Re: Warehouse Addition, 120 Morningside Dr. SE
Grading and Drainage Plan
Engineer's Stamp dated 9-7-06 (K17/D87)

Re: Warehouse Addition Grading Plan Certification
120 Morningside Dr. SE
Engineer Cert Stamp dated 9-21-09 (K17/D87)

**RE: WAREHOUSE ADDITION, 120 MORNINGSIDE DR. S.E.
(K17-D87)**

Re: Warehouse Addition, 120 Morningside Dr. SE
Grading and Drainage Plan
Engineer's Stamp dated 8-15-06 (K17/D87)

CITY OF ALBUQUERQUE

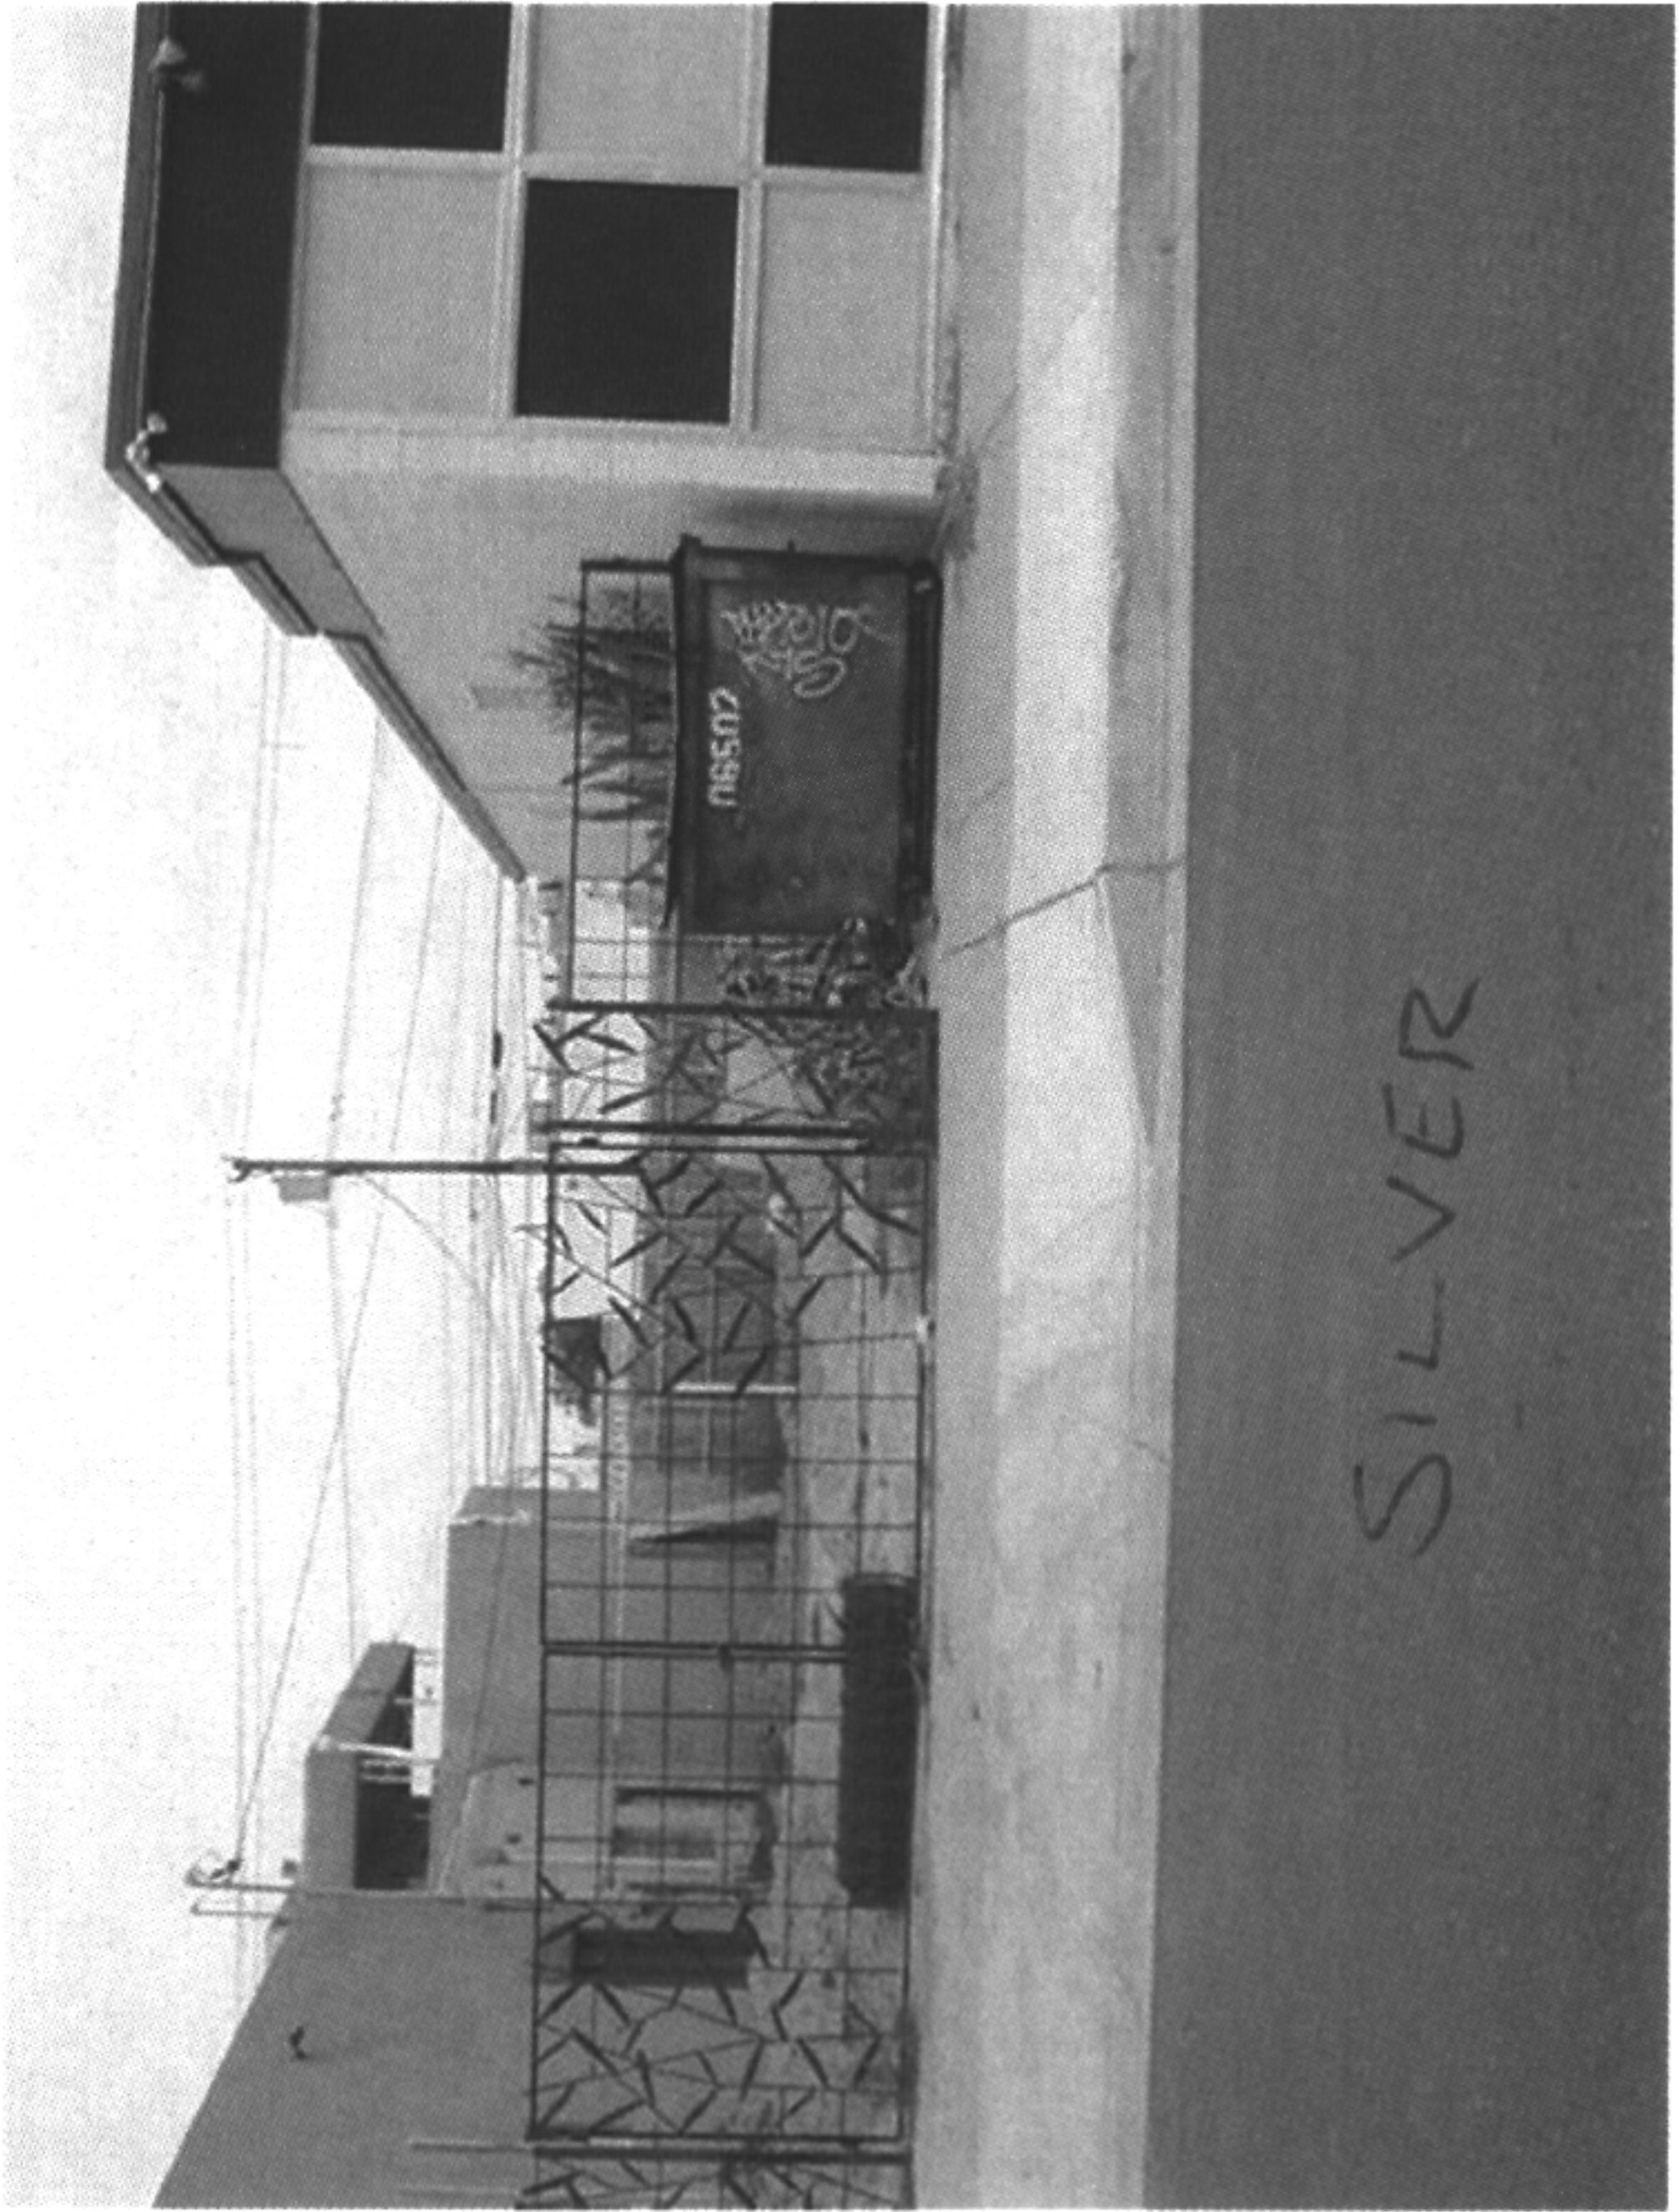
- The rundown in NE corner of the plaza was shown as deleted and this rundown is an integral feature of the drainage plan; it was needed to convey water away from the building. It is likely that water will pond adjacent to the addition and could cause issues with the foundation. If your client and the adjacent owner acknowledges this fact and will do so in writing, it could be allowed.

- Do any offsite flows enter this site? Provide existing spot elevations or contours for this site as well as the lot north of this site.
- Since the drivepad on Silver Ave. is no longer being used, it will have to be removed and new sidewalk and curb and gutter constructed. Drainage from the site will then be conveyed to Silver Ave. through a sidewalk culvert.
- How deep is the 12" concrete trough? Provide inverts for both ends.

~~Comments:~~ CURTIS, REVIEW AND SEE IF YOU CONCUR. I RAISED THE INVERTS AND I AM STILL BELOW THE FINISH FLOOR

1. Do any off-site flows enter the site? *No off-site flows enter the site from any direction. Note has been placed on the plan drawing.* Provide existing spot elevations or contours for this site as well as the lot north of the site. *Additional spot elevations have been inserted on the plan drawing for both the site and north of the site.*

2. Since the drivepad on Silver Ave. is no longer being used, it will have to be removed and new sidewalk and curb and gutter constructed. Drainage from the site will then be conveyed to Silver Ave. through a sidewalk culvert. *Two parking spaces have been designed to be located just south of the proposed building. A concrete trough will drain the roof run-off onto the new proposed asphalt within the parking spots. From that point it will drain out the existing drivepad. The existing drivepad will be utilized.*

3. How deep is the 12" concrete trough? *The proposed concrete trough will be 12" wide by 6" deep.* Provide inverts for both ends. *Inverts have been provided on the plan drawing for each end.*
